Question 57: Do your CDUs/VDUs (crude distillation units/vacuum distillation units) employ automatic trip systems to mitigate tower level overfills? What is considered the Best Practice for high level detection and response?

Vacuum Tower with a HIPP System

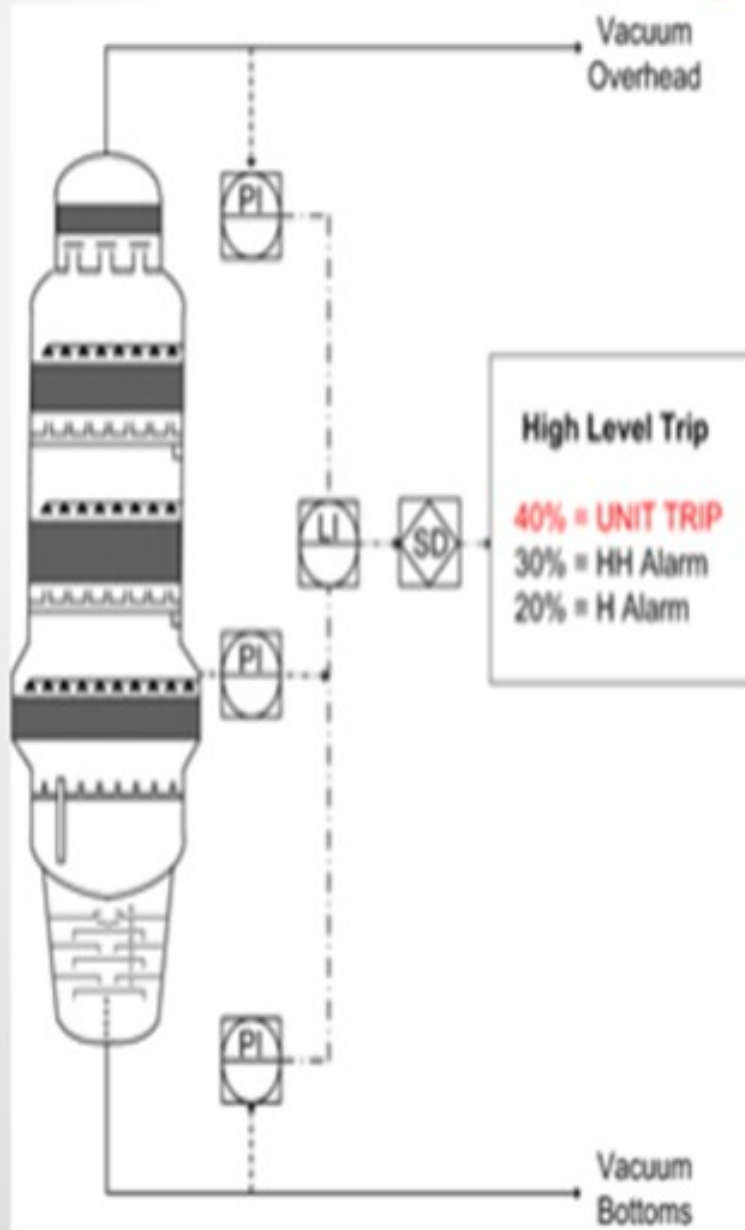
Kevin, I have two quick questions about your diagram. First, are there any special issues during startup that worry you about with cold ATB (atmospheric tower bottoms) coming into the tower? And if so, how do you account for those issues?

The second question is if you are going to pull all of the feed out of the unit trip, does that mean that you are going to shut the crude control valve if the level gets too high? **BASHAM** (Marathon Petroleum Corporation) No, this system only trips the ATB pumps and emergency isolation valves (EIVs), vacuum tower pumparound pumps, and waterwash pumps.

Sorry to pick on you, Kevin, but I have two more questions. One is: Do you know if you are going with two-out-of-three voting on those, or are they just the single transmitter?

I would also suggest that if you have not already thought about it, you might consider conditioning a signal to avoid tripping it on an instantaneous signal. The level changes slowly, so it takes a while for the signal to trigger a shutdown.

Are you incorporating any elements into the trip system to protect the upstream heater in the case of a sudden loss of heat when the trip cuts the feed out to the vacuum column?

The shutdown system level trip points were conservatively set based on liquid gravities that ranged from hot ATB to water, so cold ATB is included in this range.

This system has two-out-of-two voting.

No, this system is only guarded against an overfill scenario.
